Product change Notice
FCB-EX E series – DC-DC converter change

FCB-EX995E, FCBEX995EP, FCB-EX985E, FCBEX985EP
FCB-EX490E, FCBEX490EP, FCB-EX48E, FCB-EX48EP

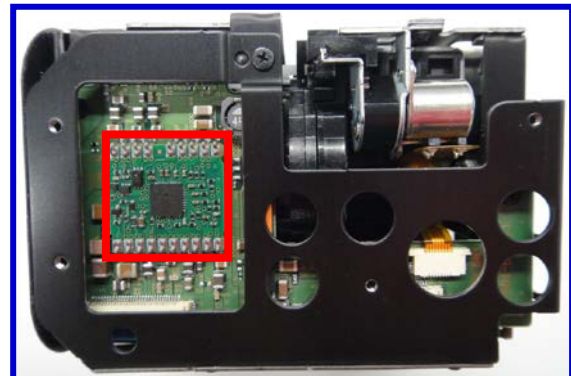
DC-DC converter supplier is changed.

Specification: Power consumption decreased by around 0.4W
EMI/EMC: no change
External appearance is modified as below:
